EGG-SSDC-5288

HUMAN FACTORS ENGINEERING EVALUATION OF  
THE ADVANCED TEST REACTOR CONTROL ROOM

M. P. Boone  
W. W. Banks

Figure 6. Evacuation and DC phones.

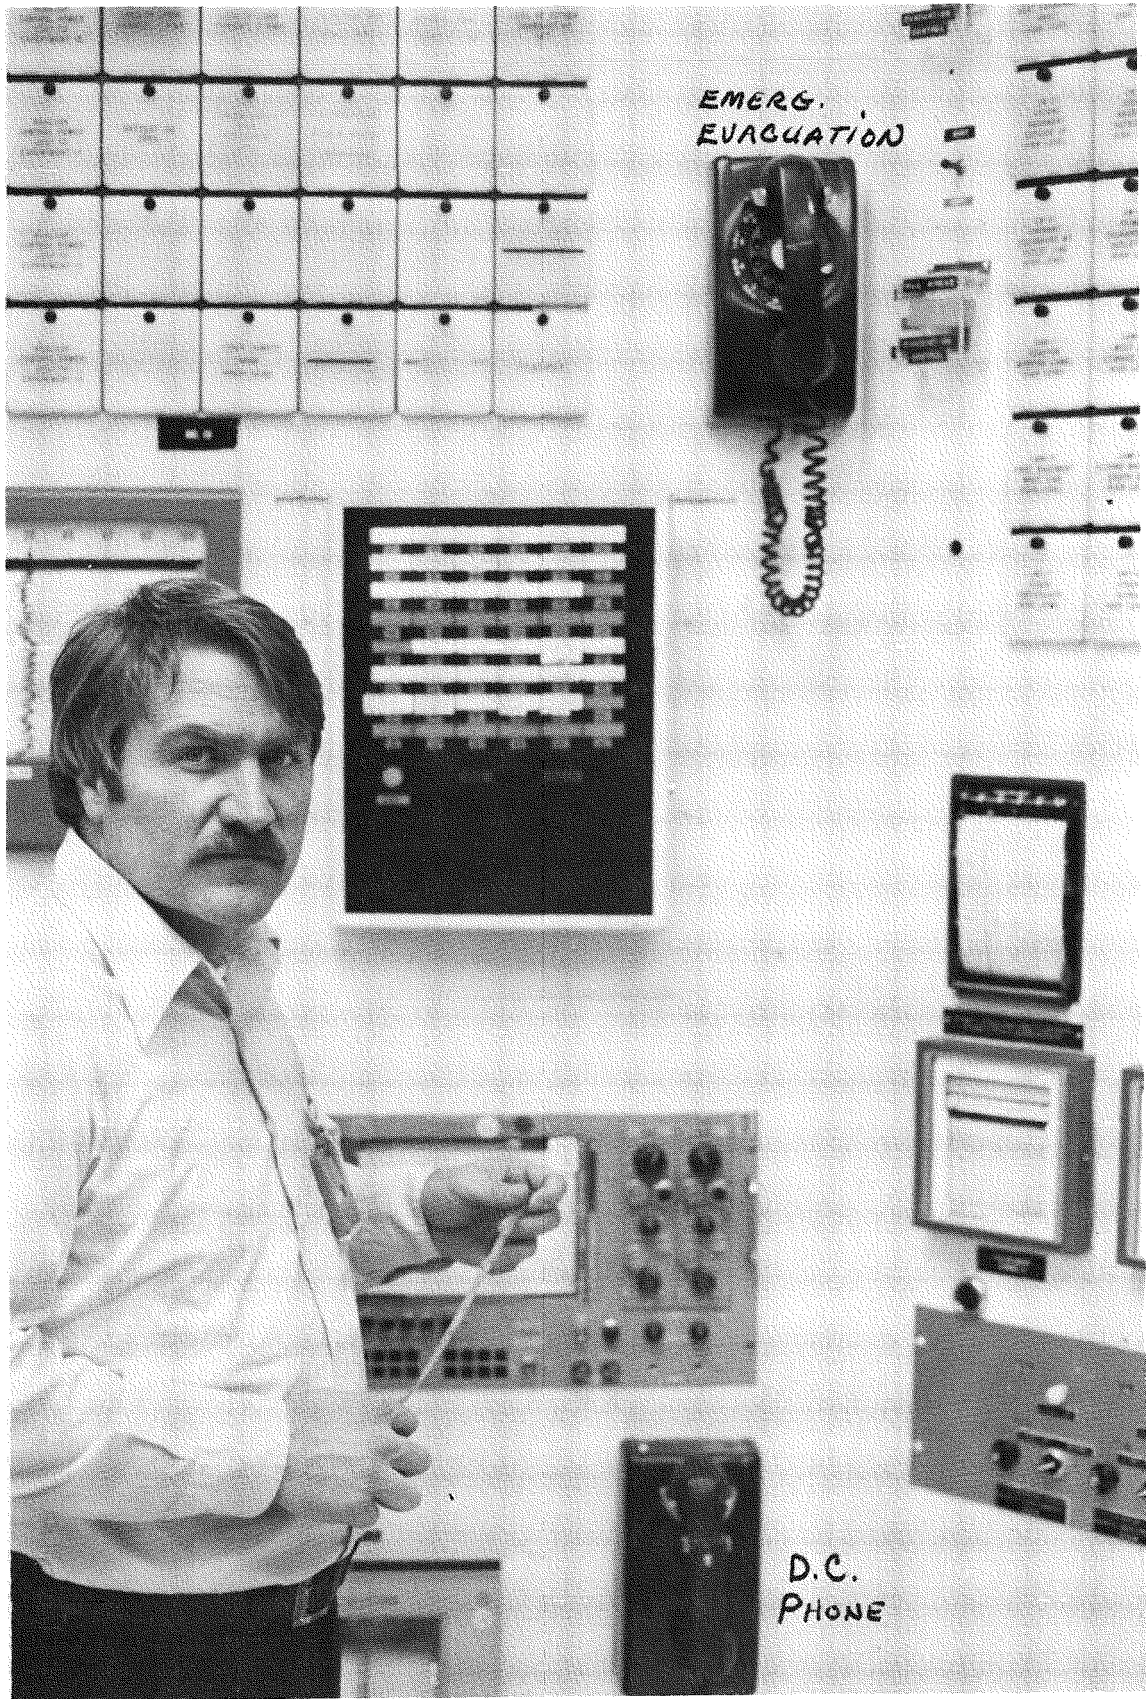
Phone No. 1, Emergency Evacuation Phone. This phone is located next to the emergency evacuation switches near annunciator panel No. 13 (Figure 6). The evacuation phone is used to coordinate evacuations with the control room at the Engineering Test Reactor (ETR). When picked up, it immediately rings in the ETR Control Room. The phone is not distinguished in any specific

manner. It is recommended the phone be RED because it is used only under special circumstances, such as emergencies or the coordination of power breakers, and not for routine messages.

Phone No. 2 DC Phone. This phone is used for coordination within the plant (Figure 6). The DC phone can be connected to a number of different stations within the plant. It is located 12 ft from the control console seat; however, it has a very long cord which is normally stretched to the control-console seat. The DC phone is used primarily when the reactor is up in power, though at times is used during other reactor states. Interconnections are made outside the control room with a patch panel. The patch panel (Figure 7) allows operators to connect into a number of stations in other parts of the building. There is the potential for connecting to 80 different stations; however, only 75 stations are currently used. Technical specifications prohibit an operator from leaving the control room during reactor operation; therefore, the patch panel cannot be accessed unless two operators are in the control room. It is recommended the DC phone be integrated into a comprehensive communication center on the reactor console and the patch panel be included as an integral part in the immediate control room. Solid-state switching can be used to miniaturize the size of the panel.

Because of the instrument's physical (height) placement, one of the shorter operators might experience problems in using the phone without the aid of a chair to stand on. We recommended that if the phone is to remain near the wind-direction indicators, it be lowered in height to 180 cm or lower<sup>b</sup> (this is the reach height of a fifth percentile woman).

Figure 9. Nonfunctional Altec phone.

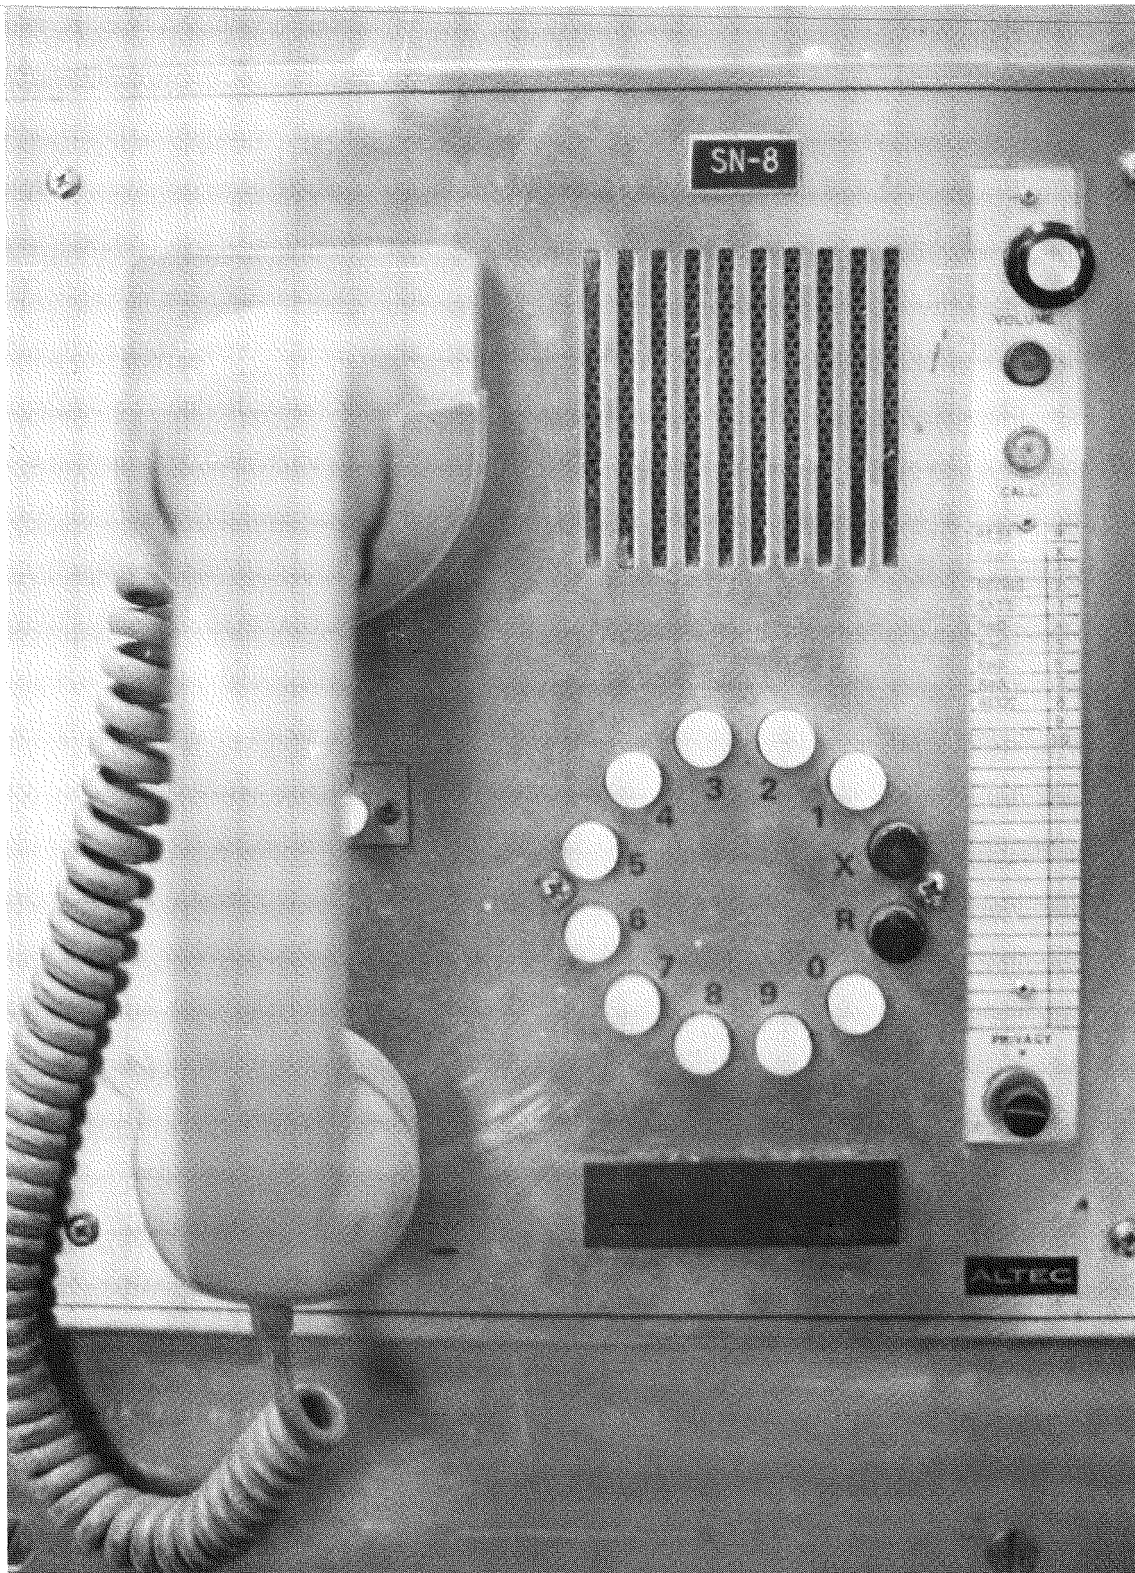
Phone No. 6, (Altec-intercom phone--Nonfunctional). Intercom Number 6 is a Bogan push-button intercom located on the left-hand console panel. The operator can contact anyone of 20 other areas within the plant. Other areas can contact the operator by pushing an intercom switch in their respective areas. This system should be removed from the control panel (see Figure 9).

Figure 10. DC PPS phone.

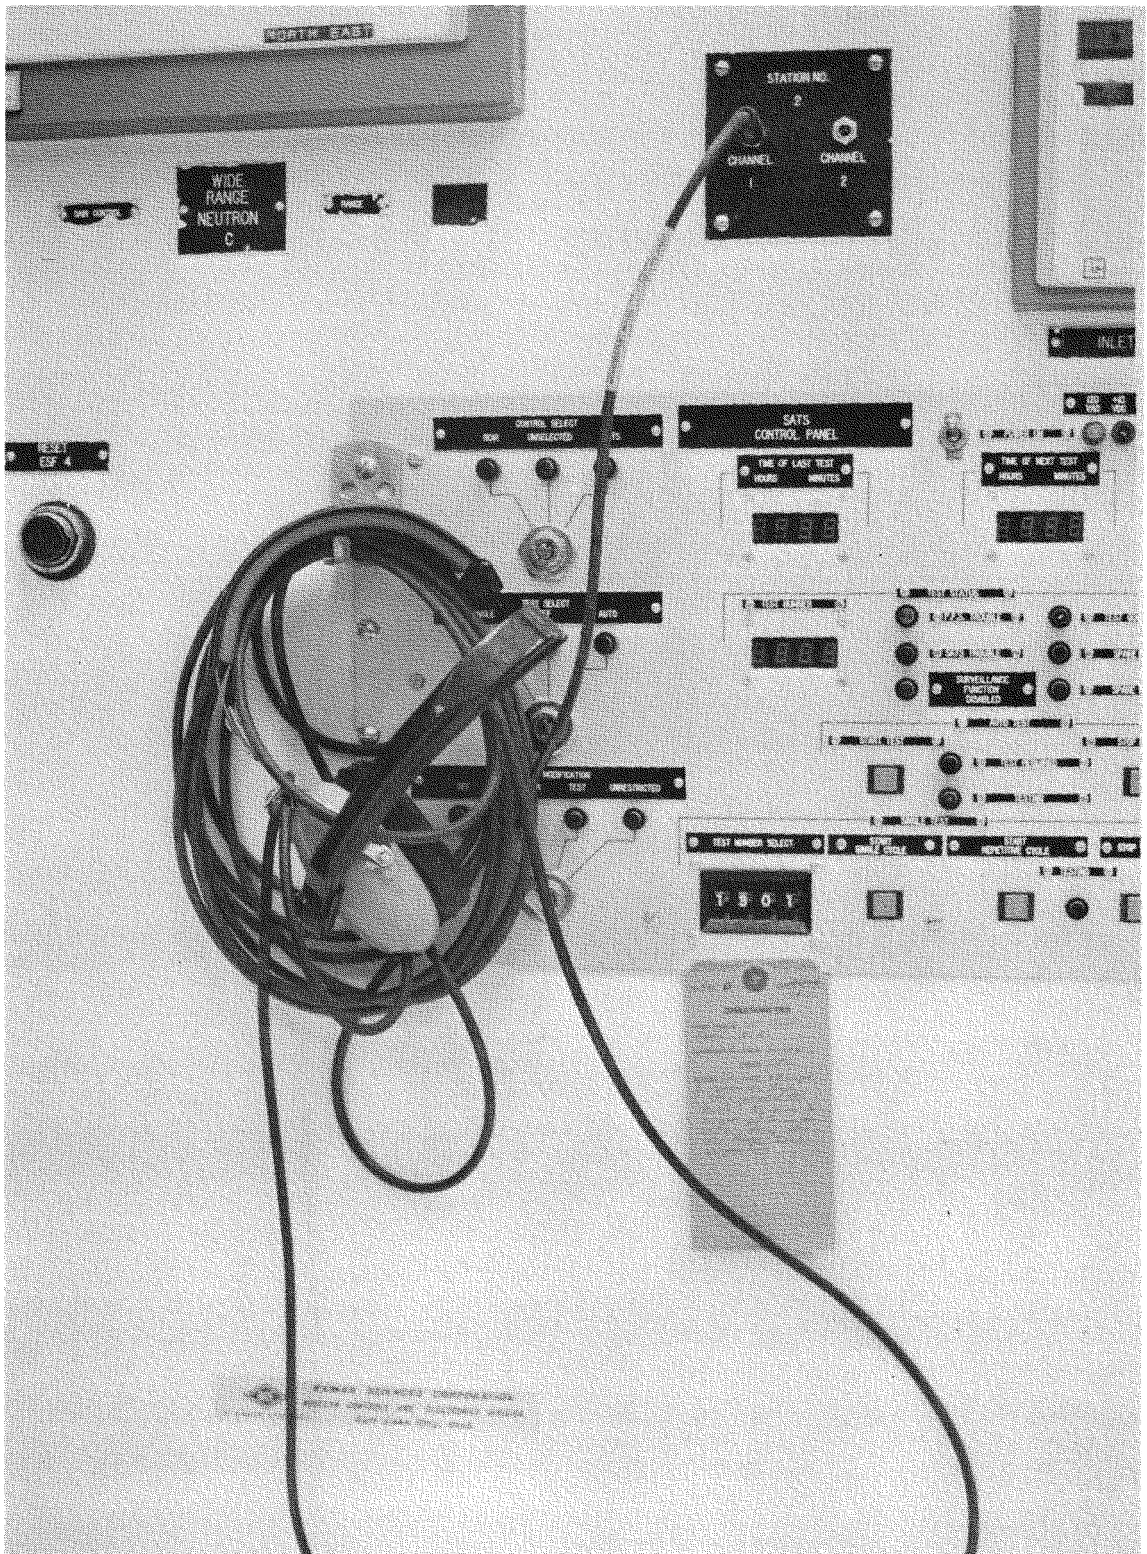
Phone No. 8, (second DC phone). This phone is located on the PPS panel and is a voice-actuated phone that is used to talk to the other PPS rooms and transmitter. The phone is hard-wired into all locations. It is used primarily when testing PPS division logic systems. The PPS DC head set is located 13 ft from the chair in the console (see Figure 10).

Figure 12. Desired power split written in grease pencil (circled).

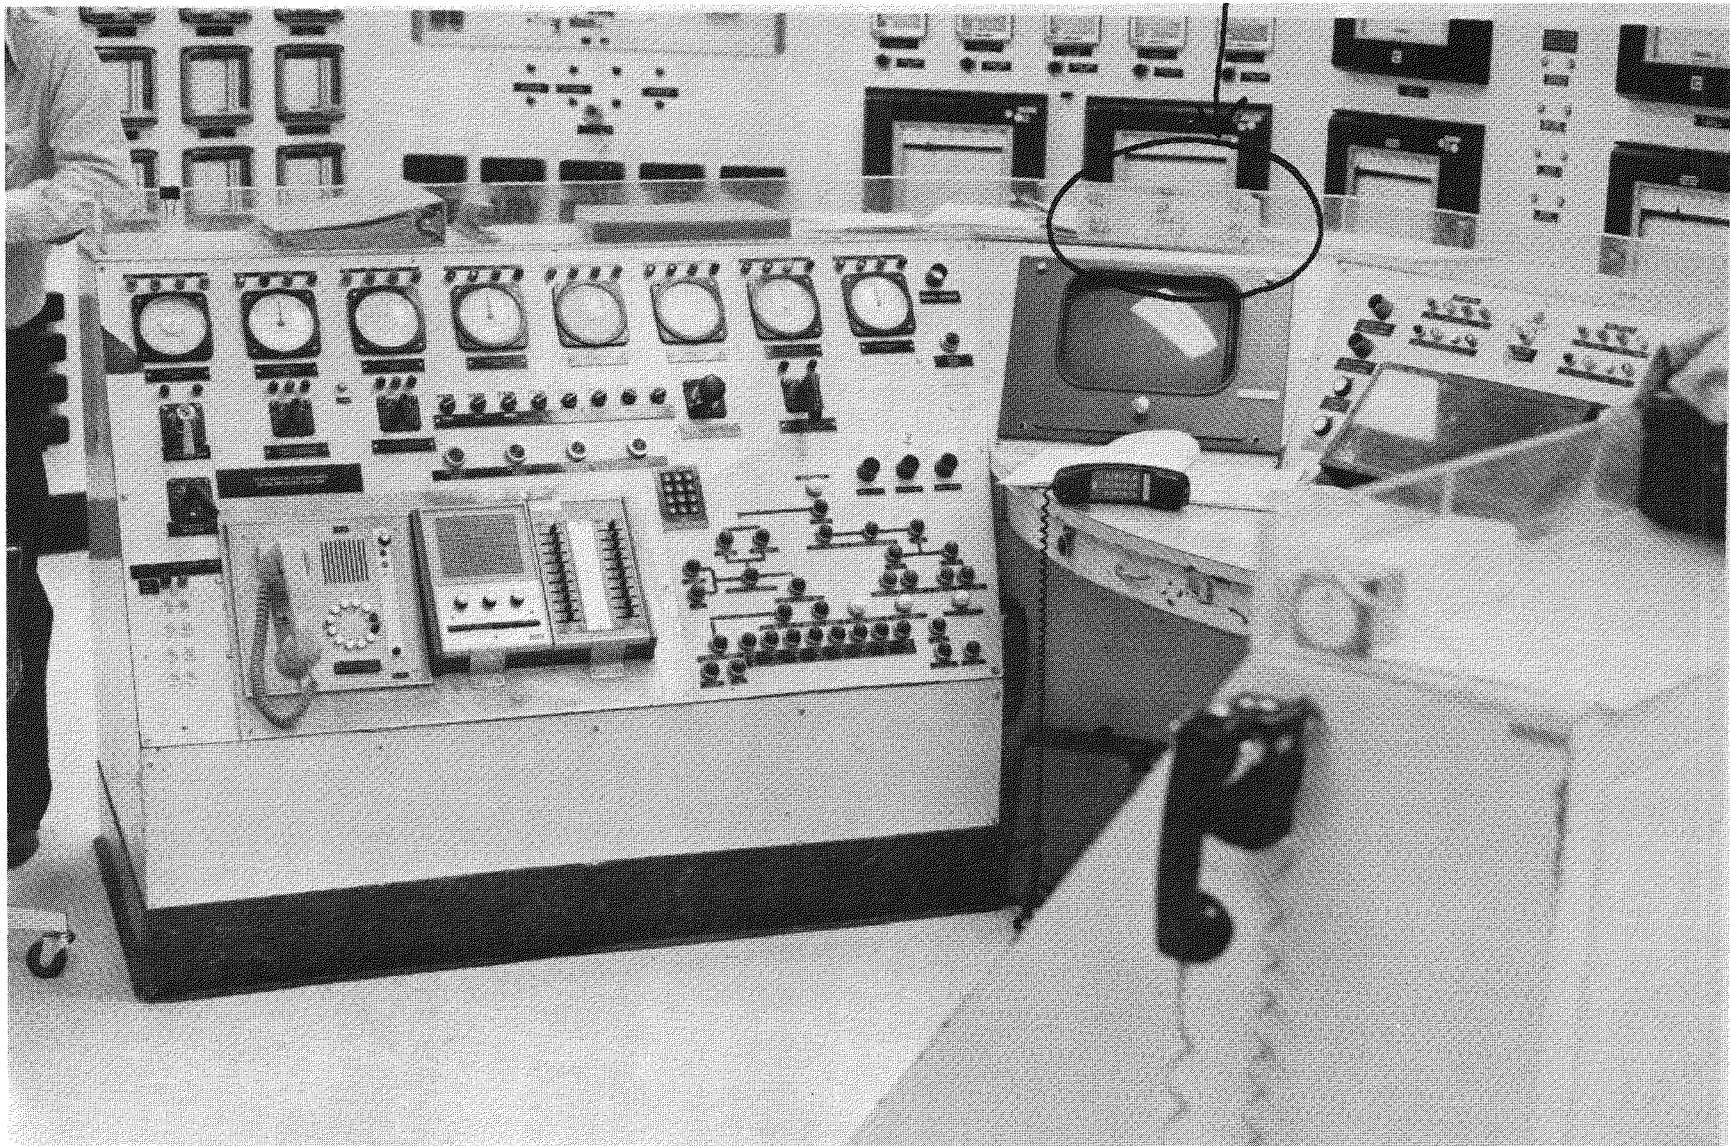
Cosmetic Appearance--Maintaining the correct power split is primarily a matching task--matching the desired power levels written on the plexiglass spill guard with the actual power levels shown on the CRT. Although the grease pencil on plexiglass is a good "quick fix," a more permanent method of displaying the desired power should be considered (see Figure 12, Arrow/Circle).
